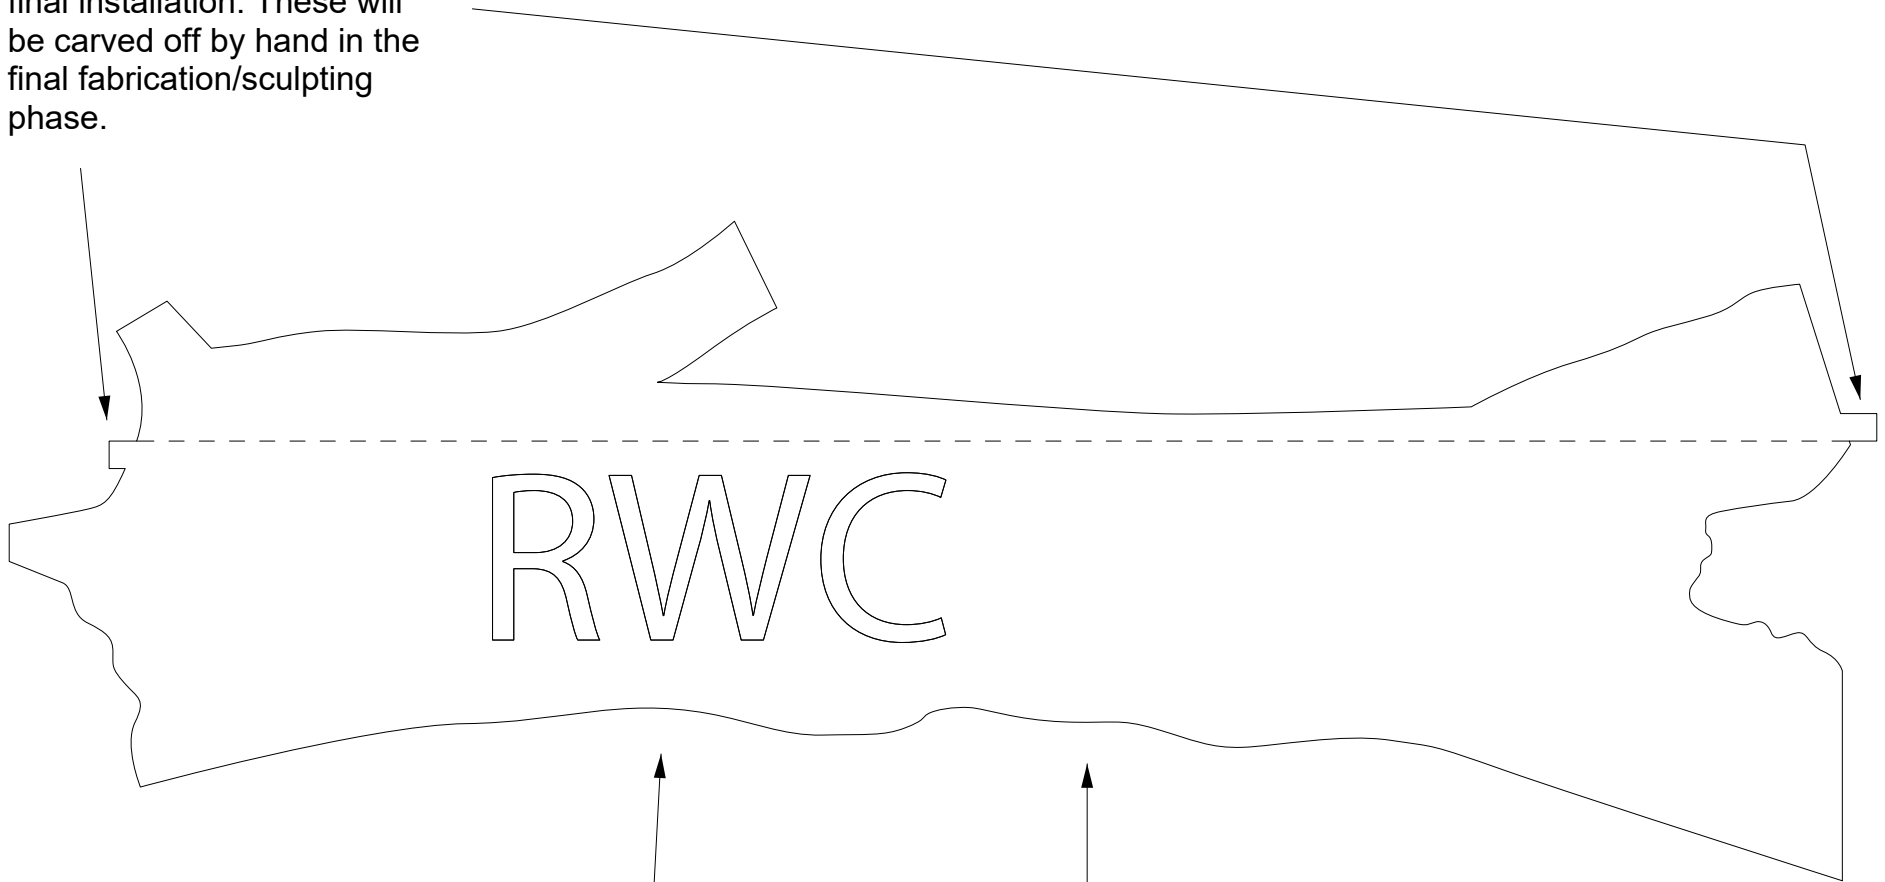
These square nubs will be used to align the cleat for final installation. These will be carved off by hand in the final fabrication/sculpting phase.

The "RWC" letters will need to be a separate layer, so that they can be engraved into the HDU.

The "rews" letters are not shown here - these letters will be cut from a separate sheet of 1" HDU. We will need to use a pin system to attach and align the letters to the 2" HDU slab. Please put pin holes on this slab that align with the holes on the back of the "rews" letters.
